City of Portland
Bureau of Development Services
Land Use Services Division

NOTICE OF A TYPE II DECISION ON A PROPOSAL IN YOUR NEIGHBORHOOD

CASE FILE NUMBER: LU 08-138088 DZM – 10151 SE STARK ST

Plan District: Gateway
Zoning: CXd – Central Commercial with design overlay
Case Type: DZM – Design Review with Modifications
Procedure: Type II, an administrative decision with appeal to the Design Commission.

SITE PLAN
SCALE: 1/16" = 1'-0"

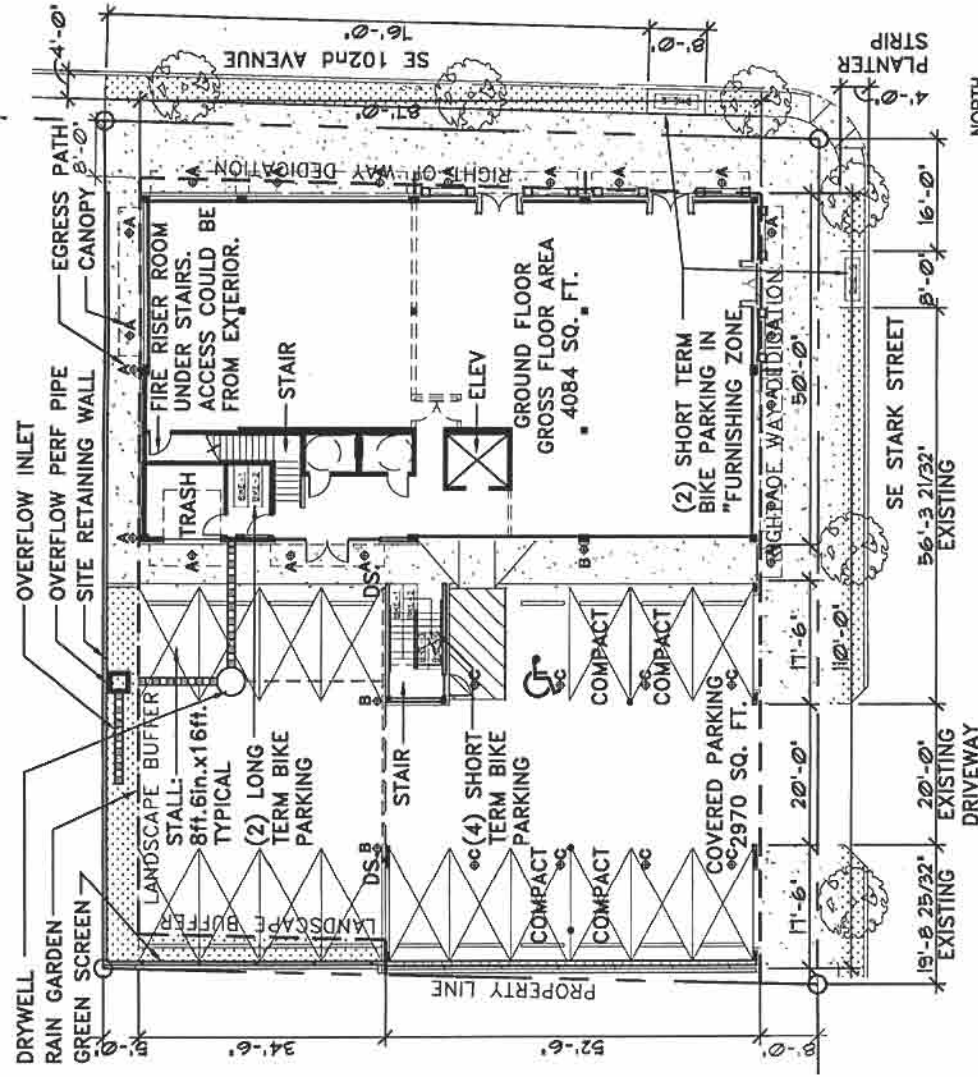
Site Development has reviewed the Additional Storm Water Narrative dated 8/26/08 prepared by Roadway Engineering, Inc. The conceptual stormwater system design ("rain garden" with overflow to a drywell) and infiltration calculations provided are sufficient for the purposes of this Design Review only. The "rain garden" area proposed exceeds the minimum area required when determined using SIM-sizing. Overflow to a drywell is acceptable. As noted in Site Development's previous Land Use Review Response, DEQ UIC registration will be required for the drywell, in addition to City requirements.

1. Roadway Engineering Inc.'s use of first flush does not match nor is it sufficient sizing for City of Portland's Stormwater Management Manual (SWMM). Plans submitted for review must be in accordance with SWMM terminology and sizing requirements.

2. The applicant must clearly and correctly identify the type of stormwater facility that is proposed, i.e. swale or flow-through planter. These facilities are sized differently and constructed differently, and neither one is a "rain garden". Again, all plans and information submitted for review must be in accordance with SWMM facility design, terminology, and sizing requirements.

3. Any drywell must be sized per the chart in the SWMM and specified on the plans. A minimum of 15-foot deep (or possibly a 20-foot deep) drywell will be required.

4. Drainage details for the surrounding parking lot, not a part of this parcel, must be included on the plans.
